Access Compliance Report

Public Rights-of-Way

(Pedestrian Signals)

Intersection ID: N/A	Main Street:	Cross Street: N/A	Location: N/A
ADA ID: CF26239088A8	Signal Type: One Push Button-Non APS	Overall Compliance: No	Severity Score: BTN 1: N/A BTN 2: N/A No BTN: N/A
Codes/Mitigation Info/Possible Solution		Field Measurements/Component Compliance

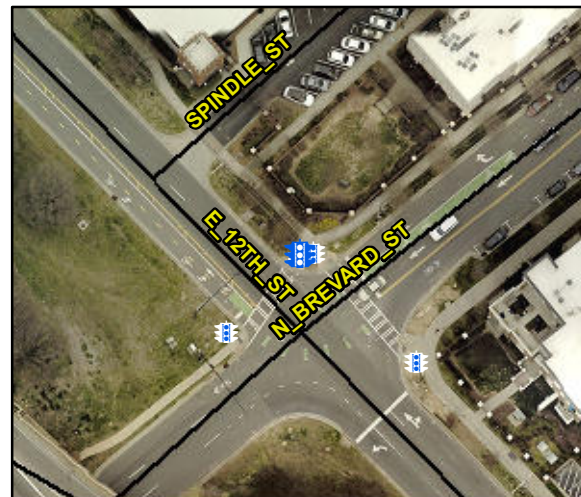
Yes	B 1 Clear Xing Direction?	ClearlyMarked	N/A	B 2 Clear Xing Direction?	N/A
	B 1 Crossing Direction	To SW		B 2 Crossing Direction	N/A
Yes	B 1 DistanceTo XWalk (in)	0.0	N/A	B 2 DistanceTo XWalk (in)	N/A
No	B 1 DistanceTo Curb (in)	90.0	N/A	B 2 DistanceTo Curb (in)	N/A
Yes	B 1 Diameter (in)	2.0	N/A	B 2 Diameter (in)	N/A

Possible Solutions: Replace Signal Push Button With APS Button on New Post. Remove & Relocate Sign.
